Item ID: DSI 9517-011
Revision ID: PRELIM
Item Name: Wearplate Installation

DART SERVICE INSTRUCTION

TO AMEND INSTALLATION INSTRUCTIONS IIN-D412-742 REV. D
AND INSTRUCTIONS FOR CONTINUED AIRWORTHINESS ICA-D412-742 REV. 3

A	NEW ISSUE	MB	10.04.21
REV.	DESCRIPTION	BY	DATE
DESIGN		DART AEROSPACE USA, INC	
DRAWN		PORT HADLOCK, WA	
CHECKED		DRAWING NO.	REV. A
MFG. APPR.		DSI 9517	SHEET 1 OF 6
APPROVED		TITLE	SCALE
DE APPR.		ALTERNATE WEARPLATE KIT	NTS
DATE	10.04.21	COPYRIGHT © 2010 BY DART AEROSPACE USA, INC THIS DOCUMENT IS PRIVATE AND CONFIDENTIAL AND IS SUPPLIED ON THE EXPRESS CONDITION THAT IT IS NOT TO BE USED FOR ANY PURPOSE OR COPIED OR COMMUNICATED TO ANY OTHER PERSON WITHOUT WRITTEN PERMISSION FROM DART AEROSPACE USA, INC.

**FIGURE 1: CHANGE AT FORWARD SADDLE LOCATION
WITH DSI-9517-011 KIT INSTALLED**

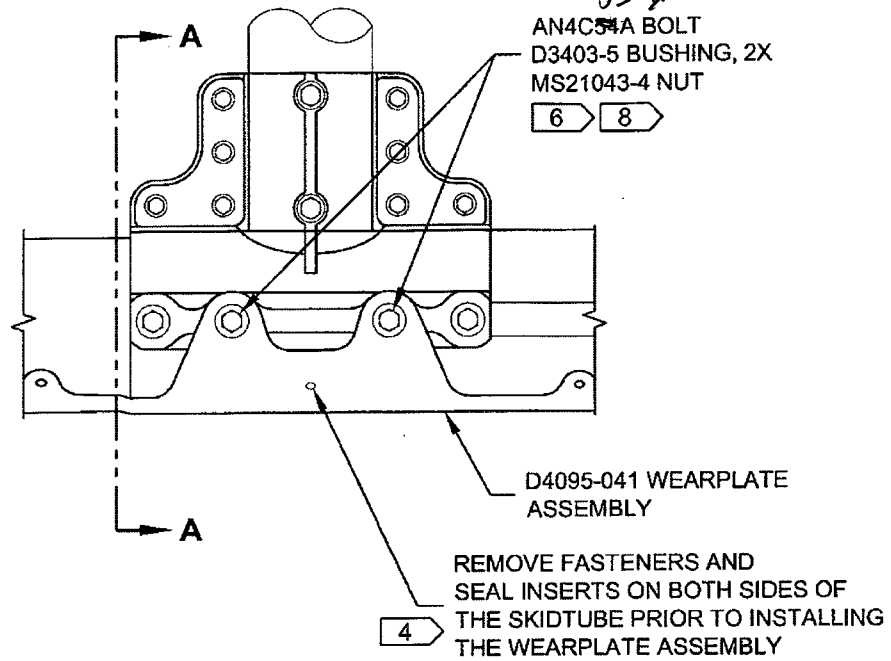
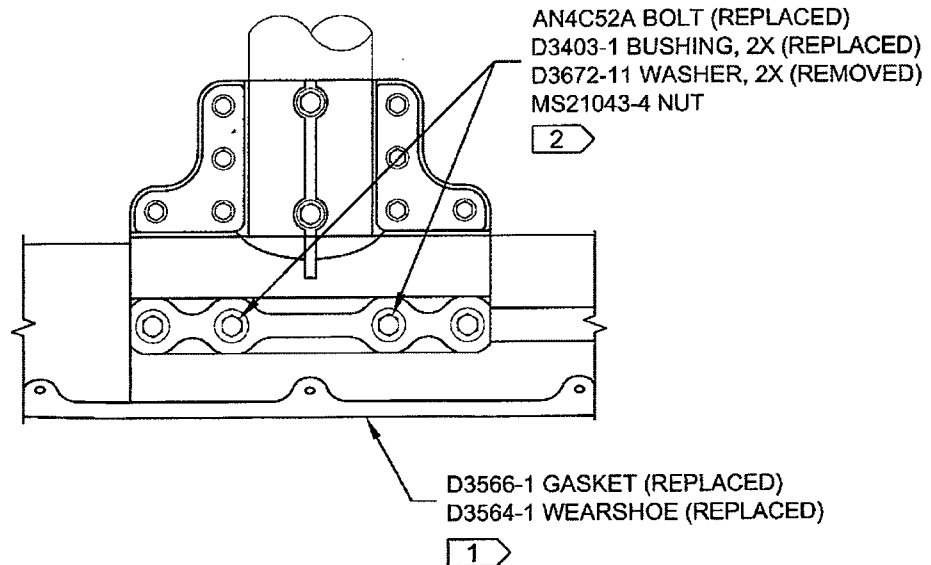
2. Remove qty.(4) AN4C52A Bolts, D3403-1 Bushings, and qty.(8) D3672-11 Washers as indicated in Figures 1 and 2 of this service instruction.
3. Inspect the skidtube and saddles per Chapter 5 of ICA-D412-742.

4. Seal existing inserts located on both sides of the skidtube in area shown in Figures 1 and 2 of this service instruction using Sikaflex -241/-291 or Proseal 890 or MIL-S-8802 Class 2B sealant.

5. Locate the DSI-9517-011 Wearplate Kit as shown in Figure 1 and 2 of this service instruction.
6. Transfer drill qty.(2) Ø0.438 hole from the skidtube/saddle to the D4095-041/-043 Wearplates Assemblies. Deburr. Touch up finish per Item 5.2.14 of ICA-D412-742 as required.

SECTION A-A

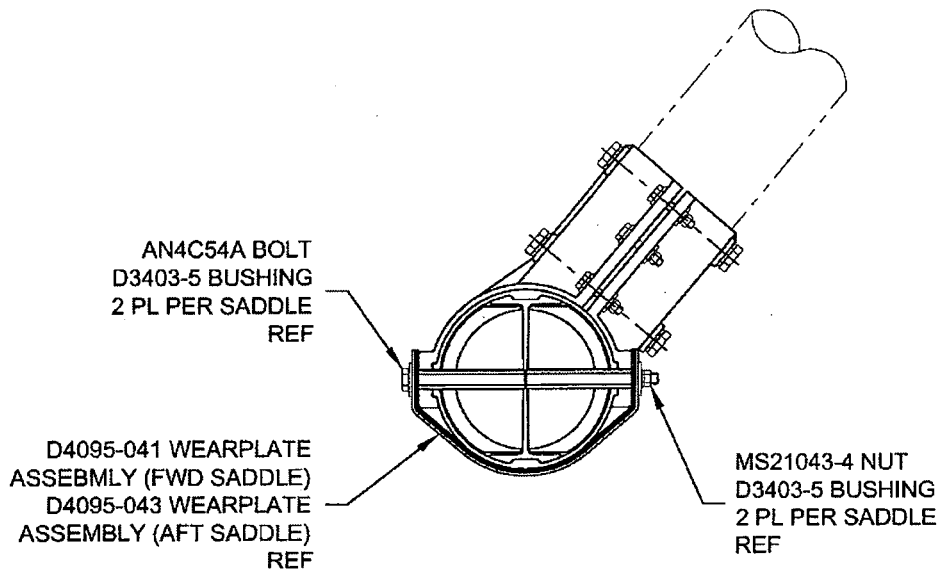
W/O: 58164		WORK ORDER CHANGES					
DATE	STEP	PROCEDURE CHANGE	By	Date	Qty	Approval Chief Eng / Prod Mgr	Approval QC Inspector
10.04.22	140	AW4C54A TOO LONG. CHG TO AW4C53A. PERMANENT CHG.				10.04.22 QSL042

QTY -011	PART NUMBER	DESCRIPTION
X	DSI-9517-011	WEARPLATE KIT
8	D3403-5	BUSHING
1	D4095-041	WEARPLATE ASSEMBLY
1	D4095-043	WEARPLATE ASSEMBLY
4	AN4C53A	BOLT

**FIGURE 1: CHANGE AT FORWARD SADDLE LOCATION
WITH DSI-9517-011 KIT INSTALLED**

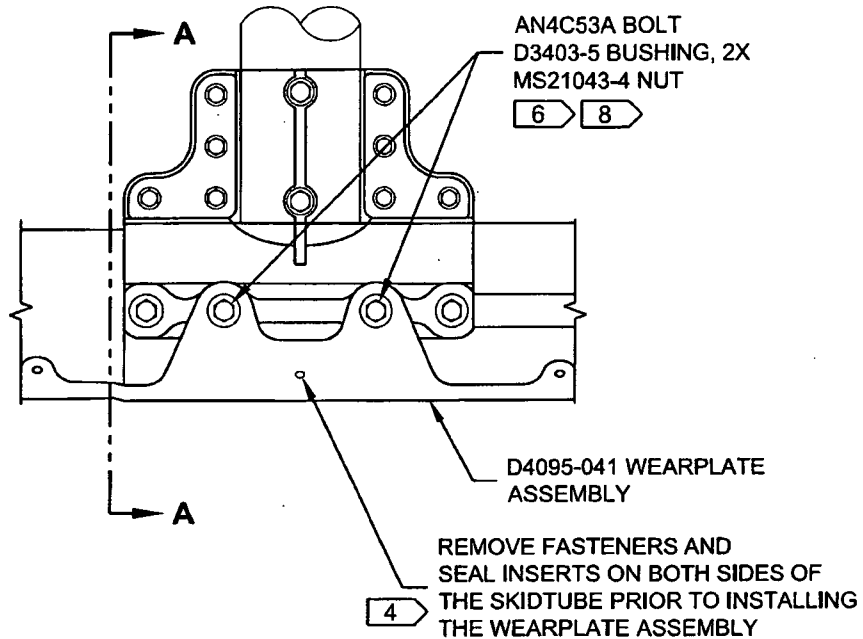
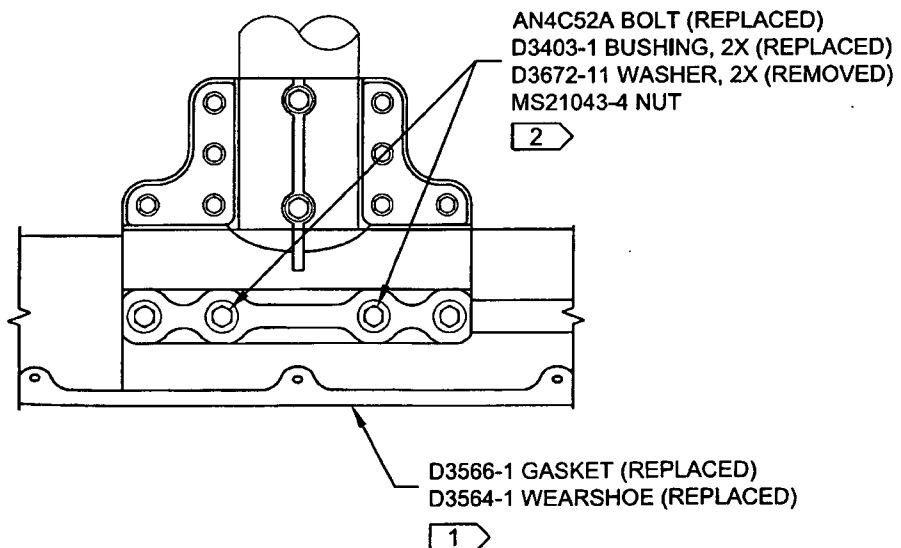
2. Remove qty.(4) AN4C52A Bolts, D3403-1 Bushings, and qty.(8) D3672-11 Washers as indicated in Figures 1 and 2 of this service instruction.
3. Inspect the skidtube and saddles per Chapter 5 of ICA-D412-742.

4. Seal existing inserts located on both sides of the skidtube in area shown in Figures 1 and 2 of this service instruction using Sikaflex -241/-291 or Proseal 890 or MIL-S-8802 Class 2B sealant.

5. Locate the DSI-9517-011 Wearplate Kit as shown in Figure 1 and 2 of this service instruction.
6. Transfer drill qty.(2) Ø0.438 hole from the skidtube/saddle to the D4095-041/-043 Wearplates Assemblies. Deburr. Touch up finish per Item 5.2.14 of ICA-D412-742 as required.
